Appln No. 10/752,382

Amdt date July 22, 2005

Reply to Office action of January 24, 2005

Amendments to the Drawings:

FIG. 6A

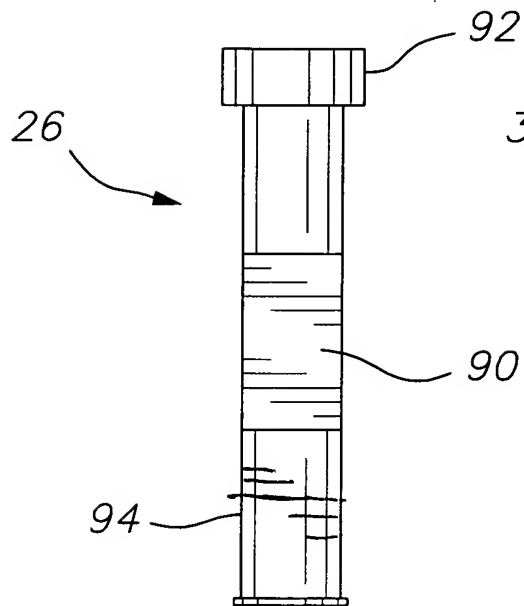
The attached sheet of drawings includes changes to Figs. 6A and 6B. This sheet, which includes Figs. 6A and 6B, replaces the original sheet including Figs. 6A and 6B.

The Examiner has rejected claims 18 and 21 as failing to comply with the enablement requirement. Specifically, the Examiner is unclear how pin 36 could be inserted past portion 38 of the frame. The specification clearly states that the shape of the pin is not critical but rather it should conform to the shape of the openings. See pg. 7, lines 33-35 and pg. 8, lines 3-6. Accordingly, Figs. 6A and 6B have been amended to show a pin that conforms as described. Applicant submits herewith an amended set of drawings showing an amended pin in Figs. 6A and 6B. Accordingly, Applicant respectfully requests that the
